Appl. No. 10/766,250 Amdt. dated June 27, 2006 Reply to Office Action of April 27, 2006 Attorney Docket 17299

AMENDMENTS TO THE DRAWINGS

REMARKS/ARGUMENTS

Fig.1c

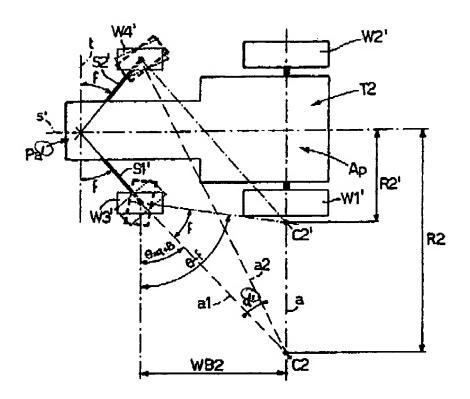
The drawings have been objected to under 37 CFR 1.84(p)(5) for failing to include reference sign(s) mentioned in the description. Appropriate corrections to the drawings have been made. In particular, reference numeral 2 has been added to Fig. 1a. Reference numeral 2' has been added to Fig. 1b along with reference numeral β ' and a ' has been added to existing reference numeral α . Fig. 1c has had a ' added to existing reference numeral Pa and existing reference numeral α has had a " more clearly marked. Grounds for the corrections to the drawings can be found in the specification, in particular on pages 6-10. No new matter has been added. A clean copy of the replacement sheets is attached to this amendment along with a marked-up copy of the replacement sheets showing all changes circled. Withdrawal of the objection is respectfully requested.
